STAFF RECOMMENDATION

306 South 15th Street

March 17, 2021

Application: New Construction—Outbuilding; Setback Determination

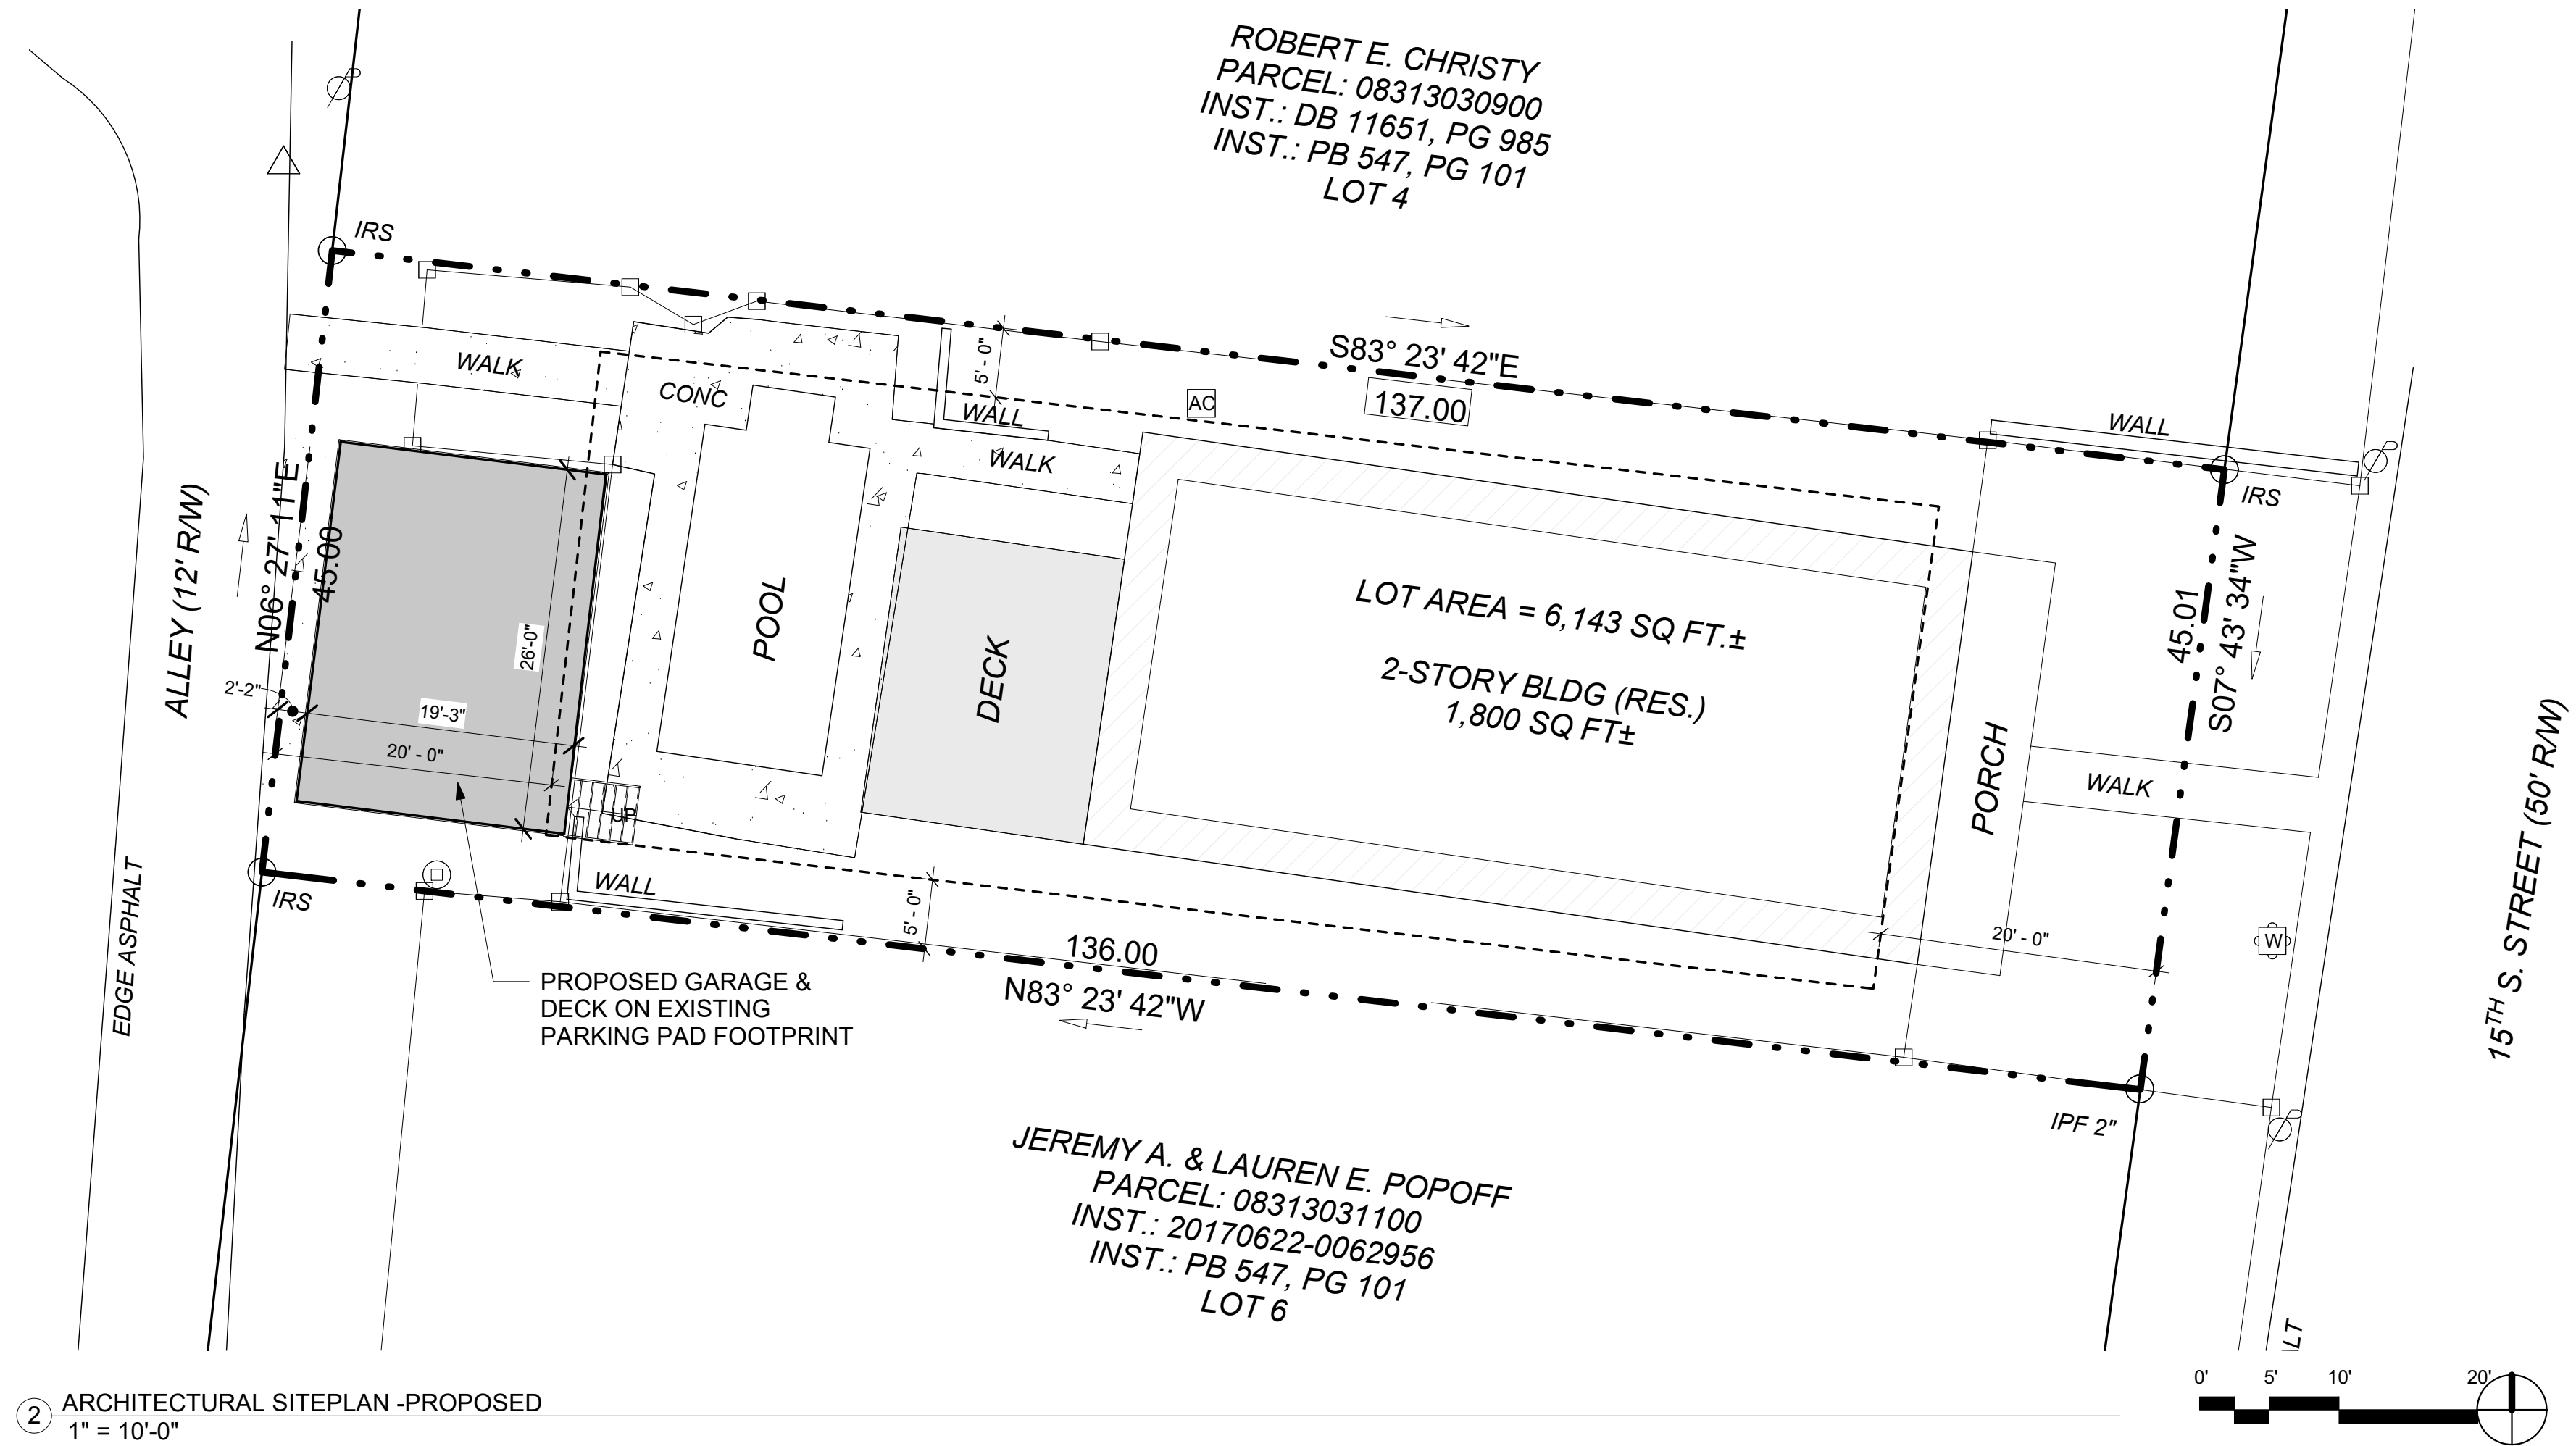
The applicant proposes to construct a garage that is just two feet, two inches (2'2") from the rear property line, whereas the design guidelines typically require five feet (5'). The applicant has indicated a willingness to meet a three foot (3') setback but does not want to increase the setback beyond three feet (3'). Although the site is constrained due to the slope and the existence of a concrete retaining wall, staff finds that a setback of less than five feet (5') is not appropriate for this site because it would not allow for a vehicle to get in and out of the garage safely. Staff therefore recommends that the rear setback be at least five feet (5').

* The outbuilding does have exterior stairs leading from an existing deck to the roof of the outbuilding. There will be approximately six steps up to the roof deck, which staff finds to be appropriate because it is only a height of approximately three and a half feet (3'6"). The design guidelines' prohibition on exterior stairs was intended for stairways that would lead to an upper floor and would have a much taller height.

** The garage has a flat roof rather than a 4/12 or larger roof slope. The Commission has approved flat roofs for outbuildings when the outbuildings are one story in scale and otherwise have an appropriate height and scale, like the proposed. Staff therefore finds that the flat roof meets the design guidelines.

Design Standards: The outbuilding is one story with a flat roof form and a roof deck. Staff finds that the flat roof and roof deck are appropriate because the garage is one story, sits so much lower than the historic house on the lot, and is shorter than the house, even without the grade. Staff finds that the proposed design meets Section II.B.8 of the design guidelines.

With the condition that the concrete block be split faced and that staff approve the doors, staff finds that the known materials meet Section II.B.8 of the design guidelines.

With the condition that the rear setback be five feet (5') staff finds that the proposed outbuilding's height, scale, placement, materials, roof form, and overall design meet Section II.B.8 of the design guidelines.
